Applicant: Barnwelle, 243 Carter Road (Poe Road)

Appl. No.: SP 3/19

SUBJECT: Minor Subdivision Application No. S-3/19
Barnwelle, 243 Carter Road (Poe Road)
Tax Map Page 72.05, Block 7201, Lots 4, 5 and 6

Re: **Barnwelle**
Minor Subdivision Application
Block 7201 Lots 4, 5, & 6
243 Carter Road (Poe Road)
EP-2 (Environmental Protection 2)
Application No. S-3/19

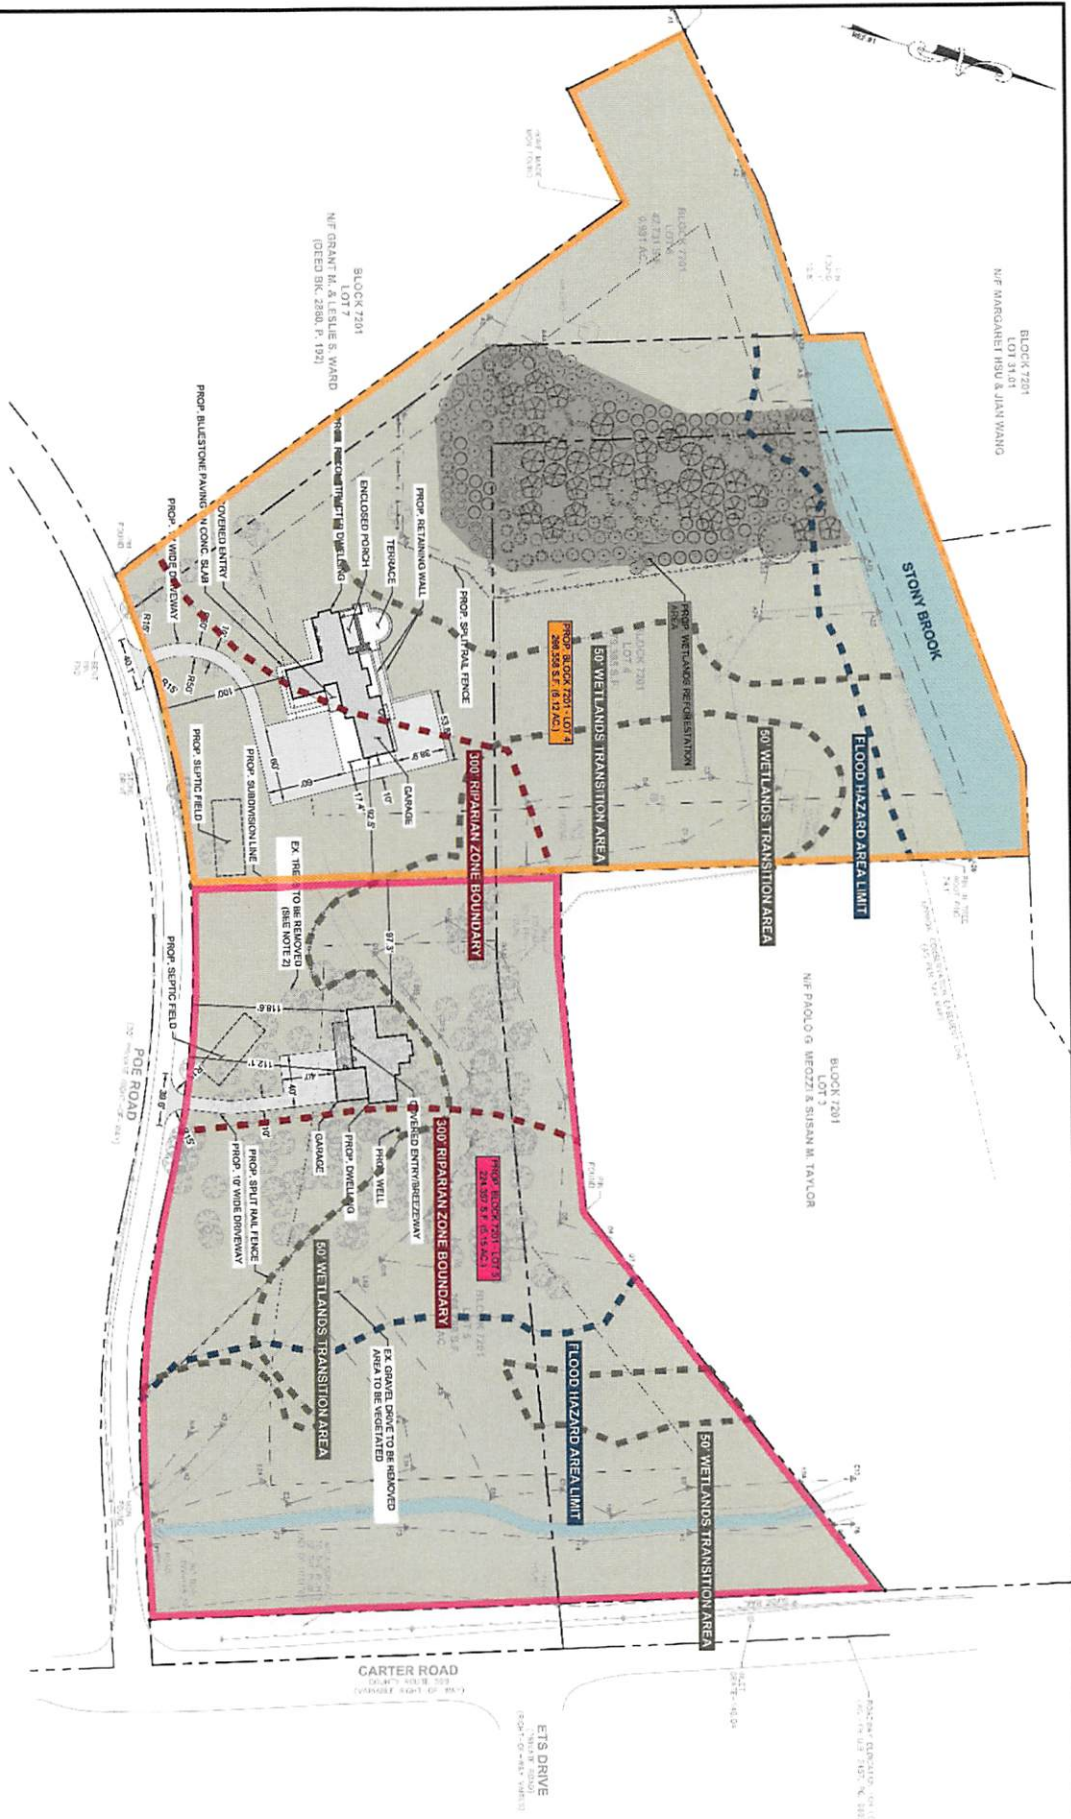
- 4.1** Sheet 3 of the Minor Subdivision Plan depicts the proposed reconstructed dwelling. Testimony should be provided regarding the nature of the reconstruction and should include to what extent the existing structure will remain.

- 4.2** Testimony should be provided regarding the existing accessory structures on the property, which include 2 gazebos and a deck along the Stony Brook. Testimony should include whether the existing structures are proposed to be demolished.

- 4.3** Testimony should be provided regarding the various environmental constraints that exist on the site and the permits that have been granted by the DEP. Testimony should include the 300-foot riparian buffer on the proposed Lot 4 and the proposed building located within the buffer.

- 4.4** Testimony should be providing regarding the methodology for calculating the minimum usable yard area.
- 4.5** Testimony should be provided regarding the proposed wetlands restoration area. The proposed plant schedule should be provided.

- 4.6** Street trees are required in accordance with §525.C.2. It appears that no street trees are currently proposed, testimony should be provided in this regard, or the appropriate relief should be sought. The Board may wish to consider requiring the street trees to be provided in clusters, rather than a linear street tree pattern. Doing so would be more consistent with the rural character of Poe Road.

- 4.7** Several mature trees exist within the limit of disturbance. Testimony should be provided regarding the preservation of existing mature trees.
- 4.8** A tree protection zone, pursuant to §541E, should be depicted on the plot plan, along with any associated tree protection fencing.

- 4.9** A detail for the proposed retaining wall should be provided.
